Access Compliance Report

Public Rights-of-Way

(Curb Ramps)

Intersection ID: 10017210	Main Street: HIGHLAND_AV	Cross Street: N/A	Location: NE
ADA ID: 729B56FBEC52	Ramp Type: PerpDiag	Initial Pass/Fail: Fail	Overall Compliance: No
Severity Score: 46.25			
Codes/Mitigation Info/Possible Solution		Field Measurements/Component Compliance

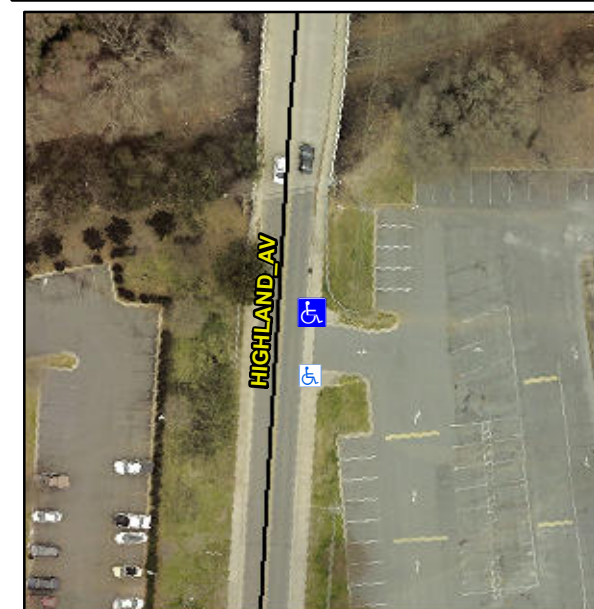
R304.5.1, R304.2.2, R304.5.3

Compliance	Description	Data	Compliance	Description	Data
N/A	Ramp Length (in)	58.5	No	Ramp Slope (%)	9.0
No	Ramp Width (in)	37.0	No	Ramp XSlope (%)	9.9
N/A	Flare Type LT	N/A	N/A	Flare Type RT	N/A
N/A	Flare Slope LT (%)	N/A	N/A	Flare Slope RT (%)	N/A
N/A	Flare Traversable LT?	N/A	N/A	Flare Traversable RT?	N/A
N/A	Landing Length (in)	N/A	N/A	DWS Provided?	N/A
N/A	Landing Width (in)	N/A	N/A	DWS Contrast?	N/A
N/A	Landing Slope (%)	N/A	N/A	DWS Length (in)	N/A
N/A	Landing X Slope (%)	N/A	N/A	DWS Full Width?	N/A
N/A	Landing Curb? (Y/N)	N/A	N/A	DWS Offset (in)	N/A
N/A	Shared Landing?	N/A			
N/A	Gutter Ponding?	N/A	N/A	Gutter Slope (%)	N/A
N/A	Gutter Lip Ht (in)	N/A	N/A	Gutter X Slope (%)	N/A
N/A	Painted X Walk1?	No	N/A	Painted X Walk2?	No
	X Walk 1 Direction	To W		X Walk 2 Direction	To S
N/A	X Walk 1 Width (in)	N/A	N/A	X Walk 2 Width (in)	N/A
	X Walk 1 Slope (%)	1.0		X Walk 2 Slope (%)	2.5
	X Walk 1 X Slope (%)	2.4		X Walk 2 X Slope (%)	9.5

Remove & Replace Curb Ramp With Two New Directional Ramps or Equivalent.
